Project	<b>IEEE 802.16 Broadband Wireless Access Working Group</b> < <a href="http://ieee802.org/16">http://ieee802.org/16</a> >	
Title	<b>A method of scanning neighbor BSs periodically - HO Ad-hoc Consensus Contribution</b>	
Date Submitted	<b>2004-06-24</b>	
Source(s)	<p>Kihyoung Cho, Yongho Kim, Changjae Lee          LG Electronics, Inc.          533, Hogye-1dong, Dongan-gu,          Anyang-shi, Kyongki-do, Korea</p> <p>Phillip Barber          Broadband Mobile Technologies, Inc.          8302 Sebastian Inlet          Frisco, Tx 75035</p> <p>Prakash Iyer          Intel          JF3-206, 2111 NE 25th Avenue          Hillsboro, Oregon 97124</p> <p>Seong-Choon Lee and Min-Sung Kim          KT(formerly Korea Telecom)          17 Woomyen-dong, Seocho-gu, Seoul          137-792, Korea</p>	<p>Voice: 82-31-450-2945          Fax: 82-31-450-7912  <a href="mailto:kihyoung@lge.com">[mailto:kihyoung@lge.com]</a>, <a href="mailto:ronnykim@lge.com">ronnykim@lge.com</a>,  <a href="mailto:cjlee16@lge.com">cjlee16@lge.com</a></p> <p>Voice: +1 (972) 365-6314          Fax: +1 (925) 396-0269  <a href="mailto:pbarber@BroadbandMobileTech.com">[mailto:pbarber@BroadbandMobileTech.com]</a></p> <p>Voice: +5

Figure E.1—Example BS advertisement and scanning (without association) by MSS request

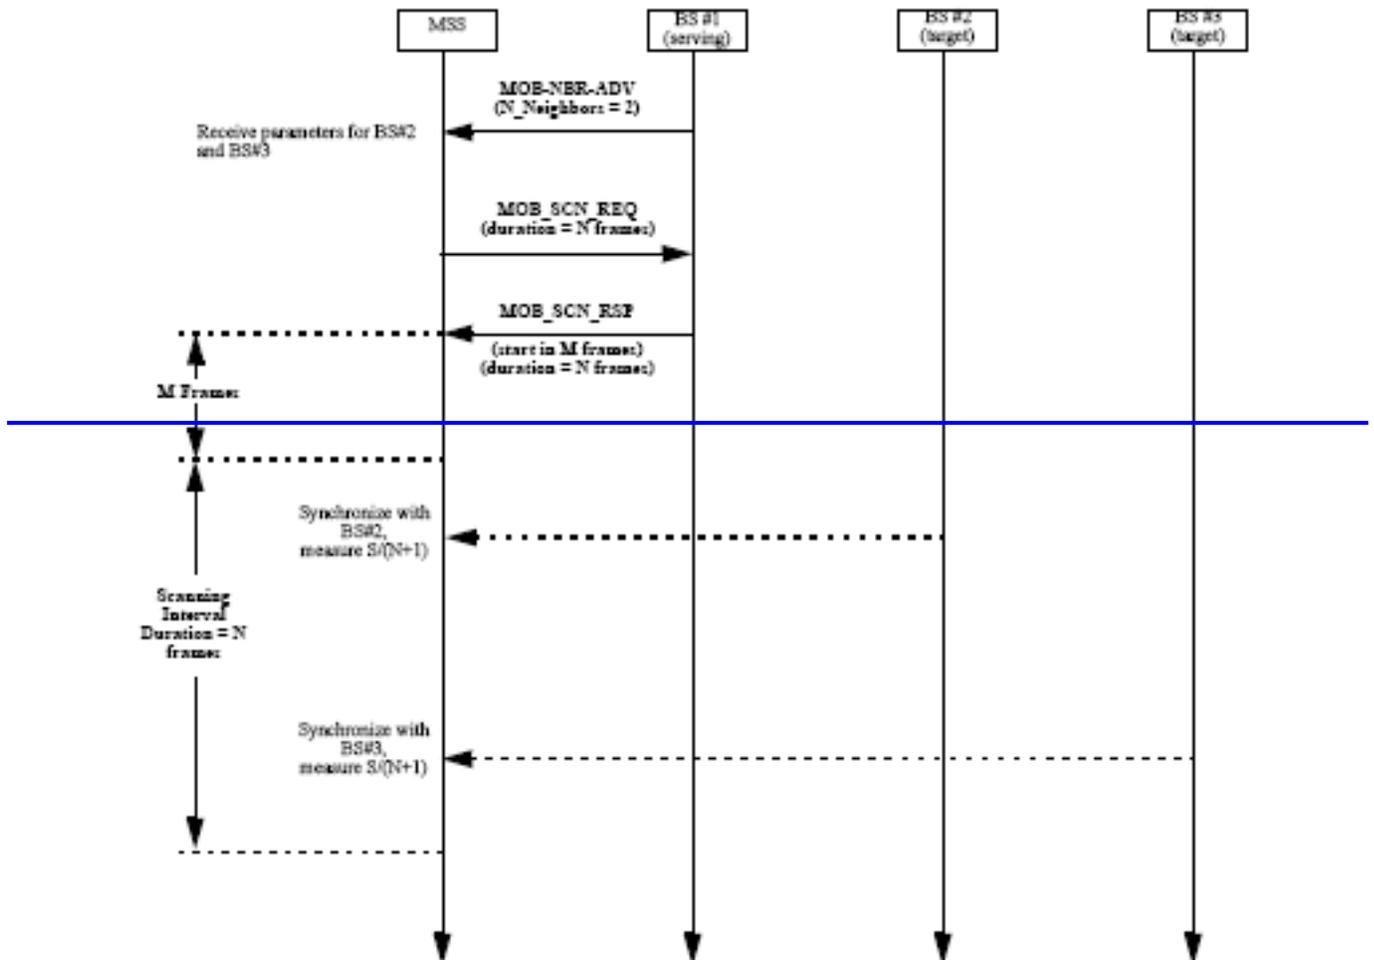
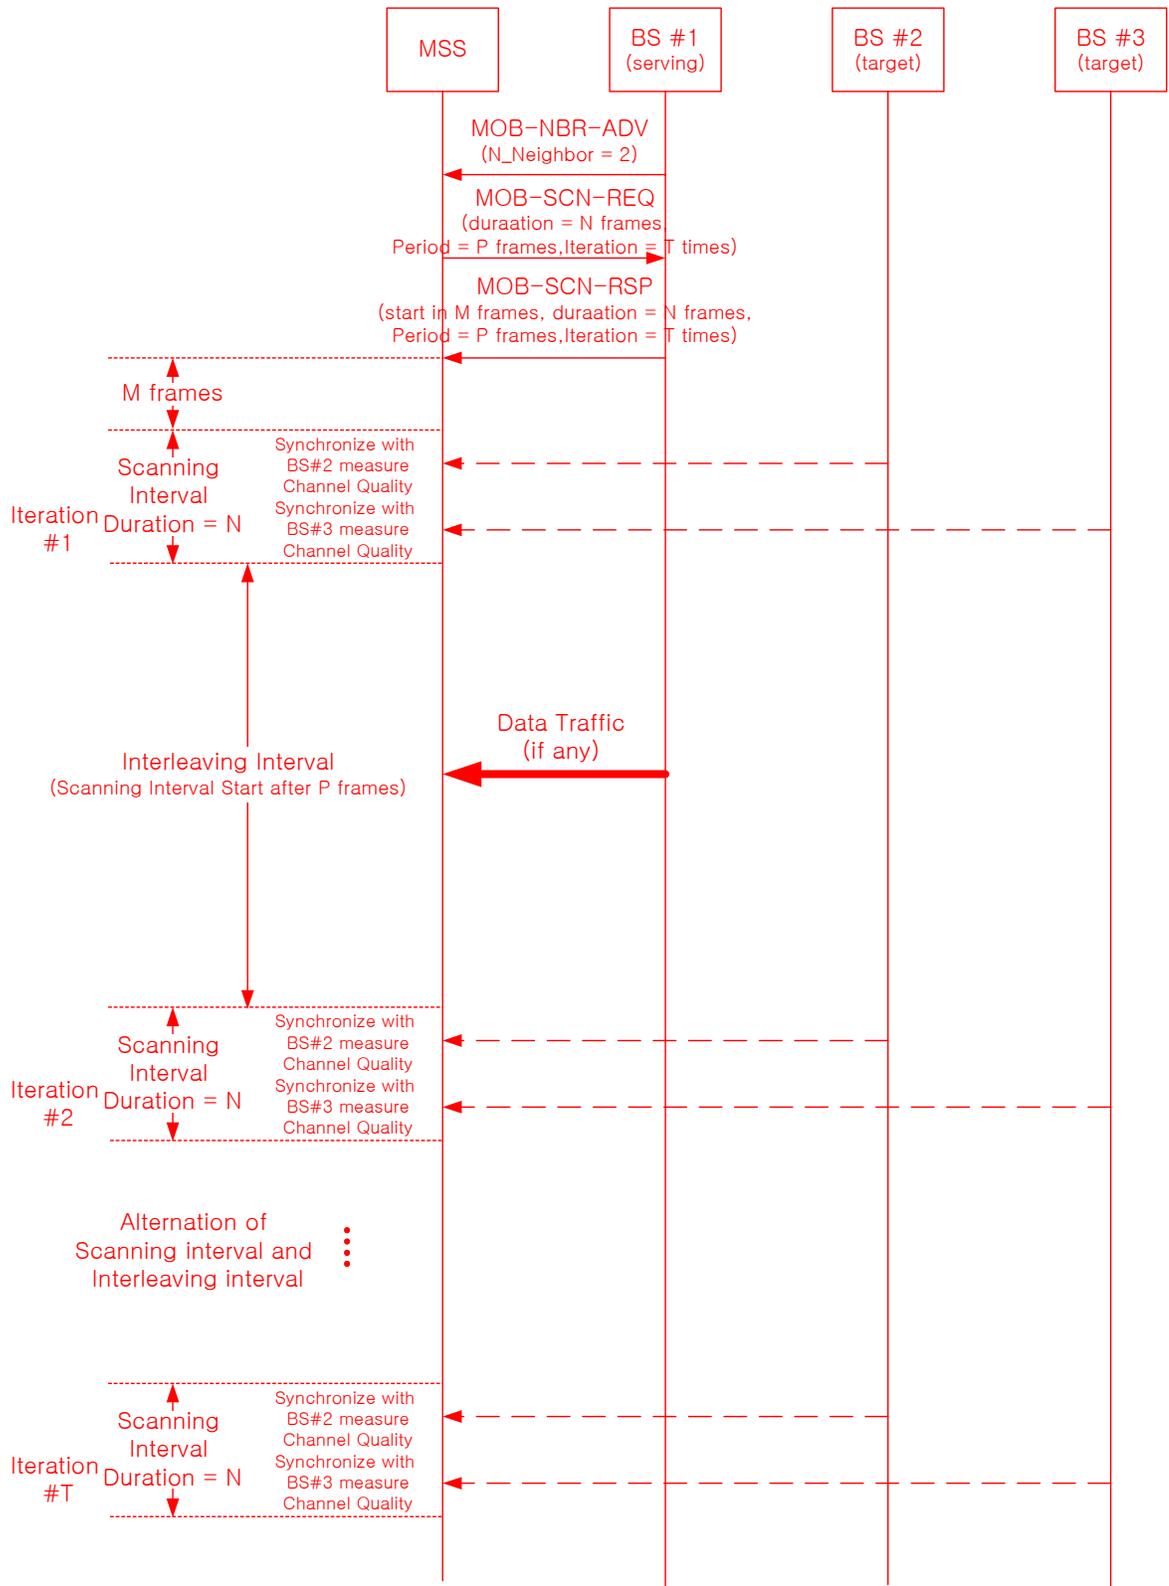
*[Modify the Figure E.1– Example BS advertisement and scanning (without association) by MSS request]*

The following figures describes the messages flow for neighbors advertisement and scanning of neighbors by the MSS request, BS request and periodic scanning of neighbors during hand-over.
